Addendum No. 2
March 13, 2025

Project: Brandon Valley Middle School Addition
Brandon, South Dakota
Project #3090

Architect: Architecture Incorporated

2.50

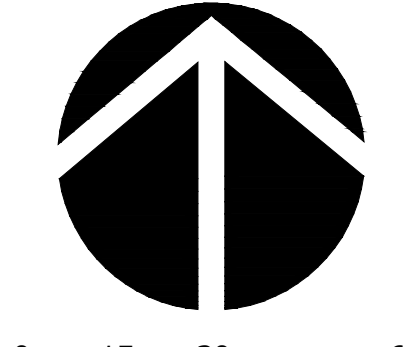
- 3) SHEET 2.50 – UTILITY PLAN
 - a) The pond outlet structure (Keynote #8) rim elevation has been revised from elevation 1362.50 to 1363.70 as indicated in *revised* Sheet 2.50, *revision* dated 3-13-2025, attached to the end of this addendum.

7. INSTALL 20 TONS OF CLASS B RIP-RAP.
 8. INSTALL 2'x2' AREA DRAIN OUTLET STRUCTURE (AD #2)
 - a. RIM: 1363.70
 - b. INVERT (12")(N): 1359.35
 - c. INVERT (4")(N): 1359.58

10 HEAD DETAIL
4.30 SCALE: 1/2" = 1'-0"

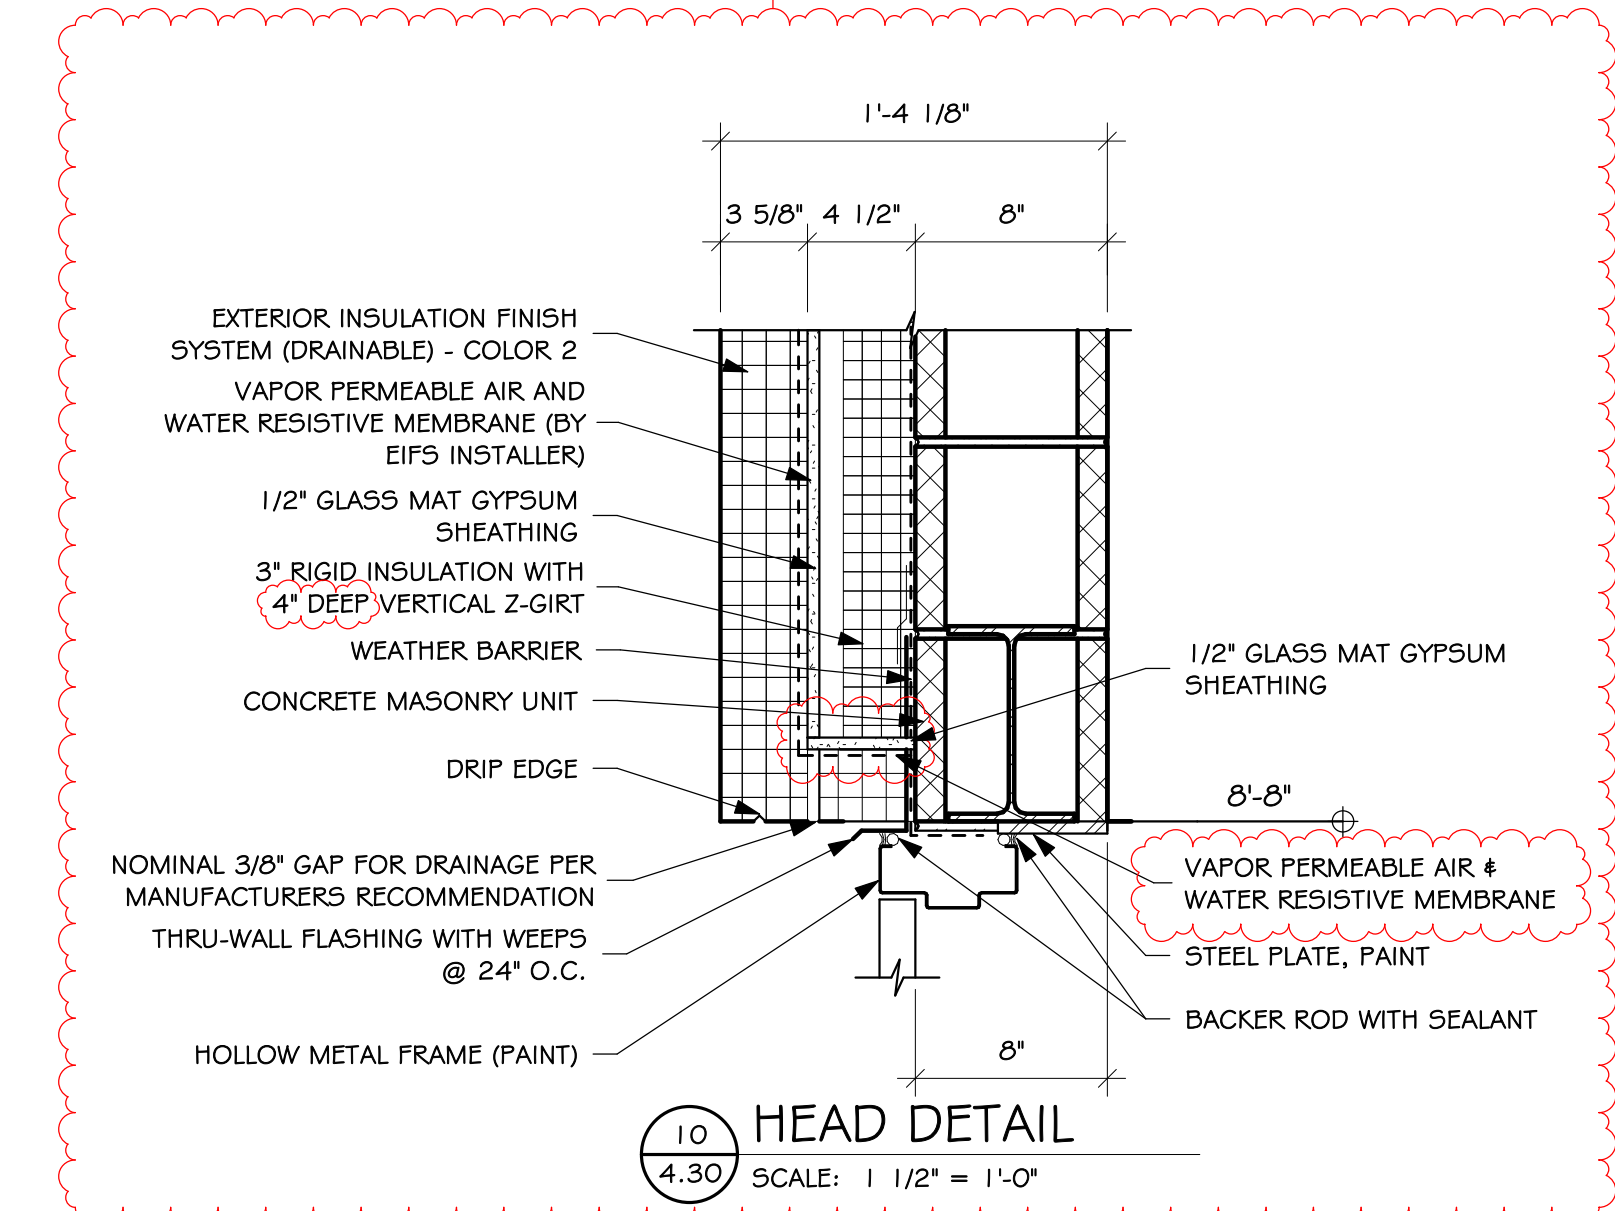
- a) CLARIFICATION – Head Detail 10/4.30:

- i) 3 5/8" deep vertical z-girt note shall be changed to 4" deep vertical z-girt.
 - ii) Vapor permeable air and water resistive membrane shall be applied to exterior glass mat sheathing as shown in revised detail 10/4.30.
 - iii) Reference revised Sheet 4.30, revision dated 3-13-2025, attached to the end of this addendum.
- b) CLARIFICATION – Door Schedule:
- i) The frame type of Door #A113 shall be changed to Type 4 as shown in revised Sheet 4.30, dated 3-13-2025 attached to the end of this addendum.
- c) CLARIFICATION: The wall above storm rated doors B132 and D145 and the borrowed lites adjacent to storm doors shall be a CMU wall extended to the bottom of hollow core floor above in lieu of steel stud wall shown in detail 1/4.31.

9.11

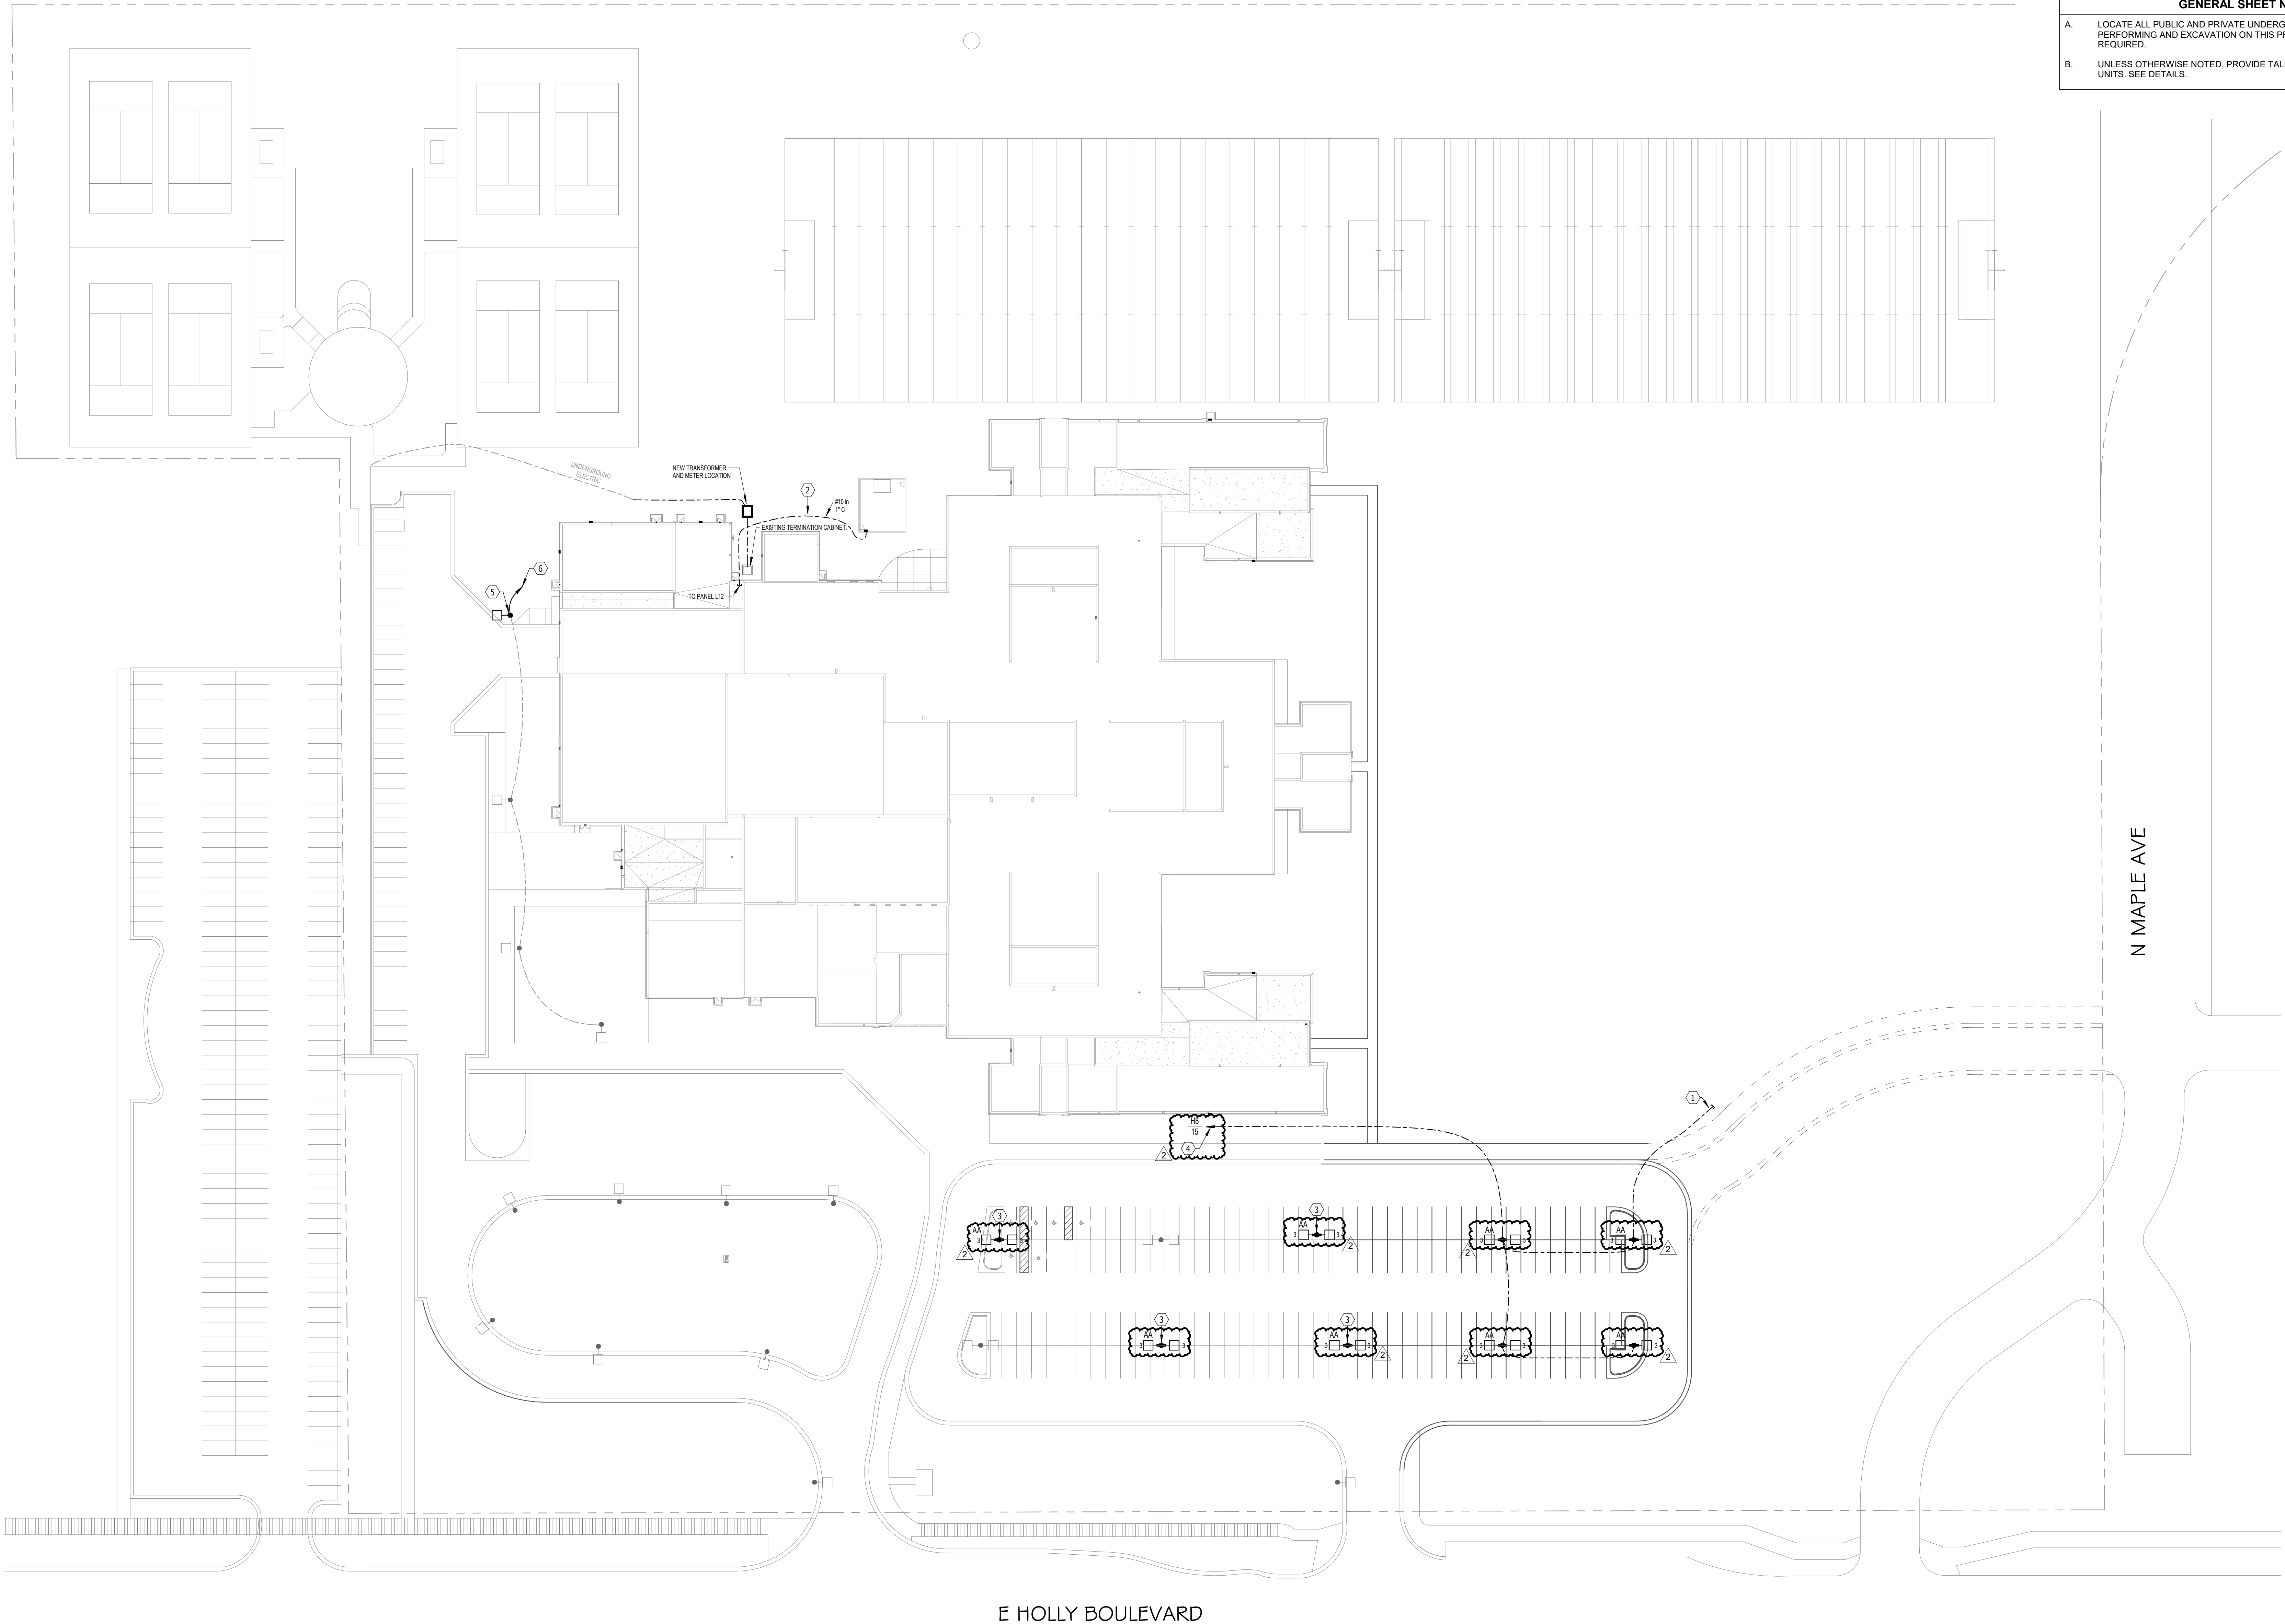
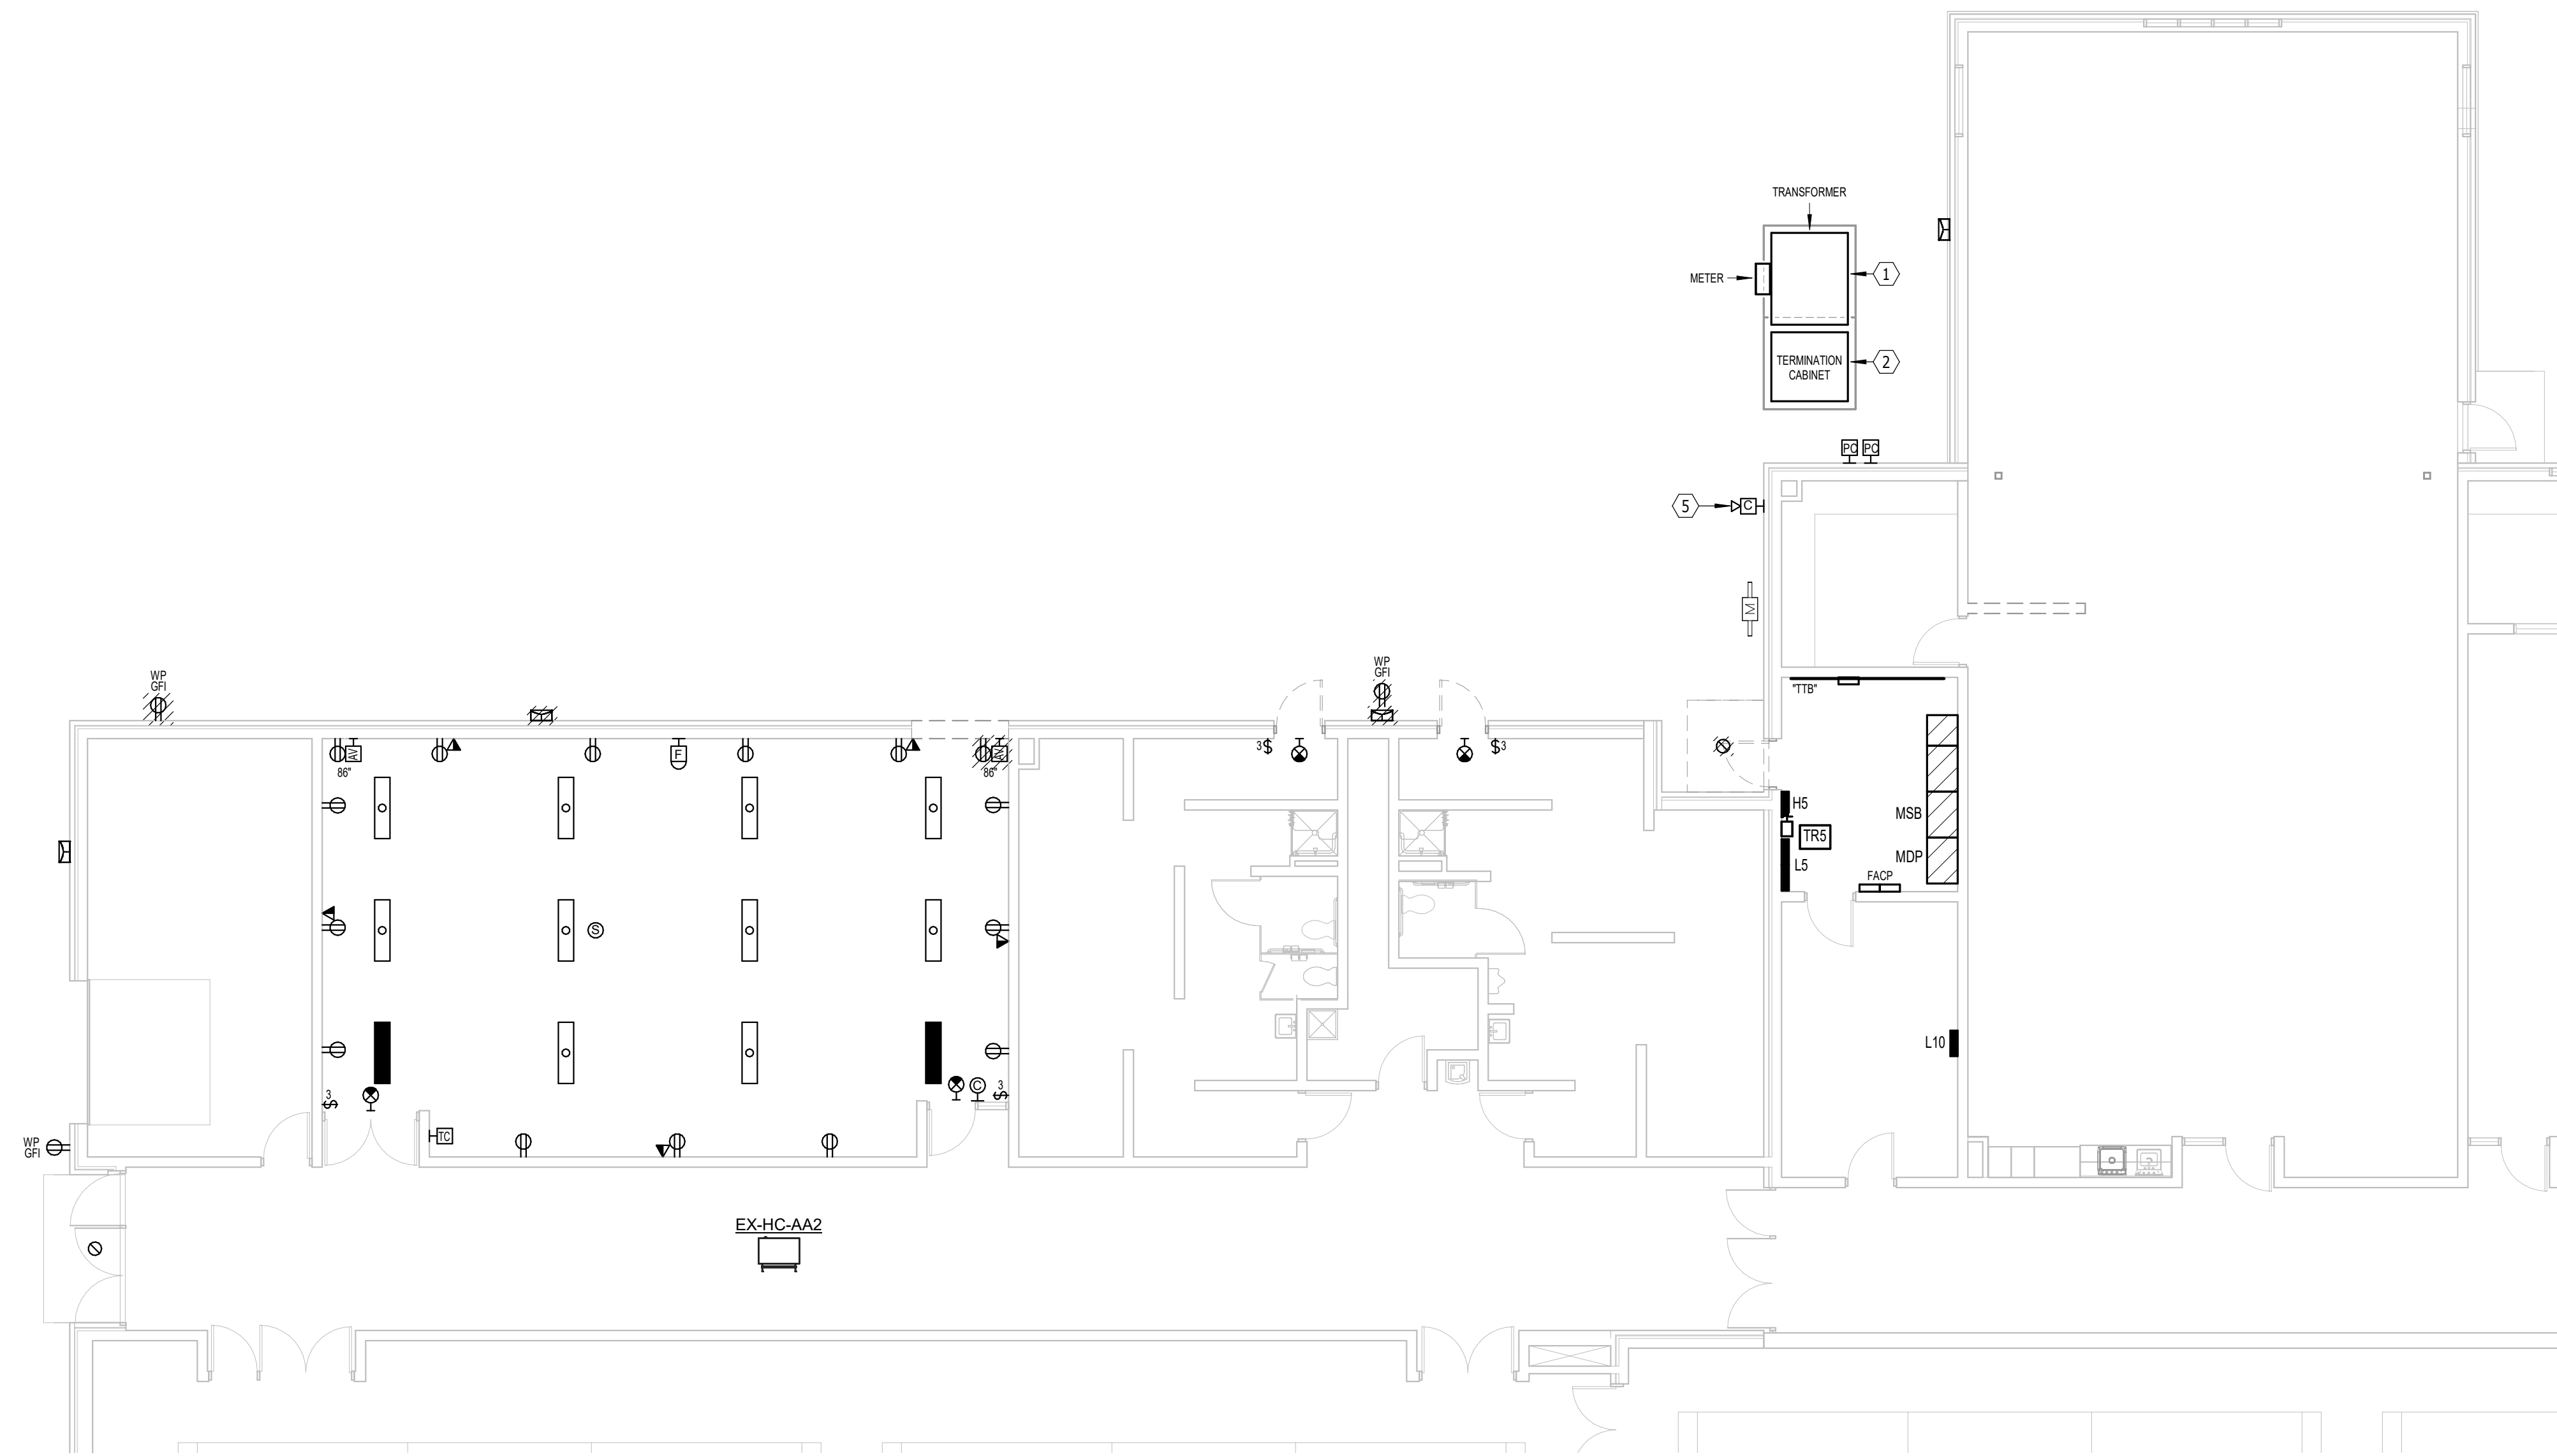
- 1) SHEET 9.11 – SITE PLAN – ELECTRICAL
 - a) Add 3 at each Type AA Pole light fixtures to indicate Type 3 distribution as indicated in *revised* Sheet 9.11, *revision* dated 3-13-2025, attached to the end of this addendum.
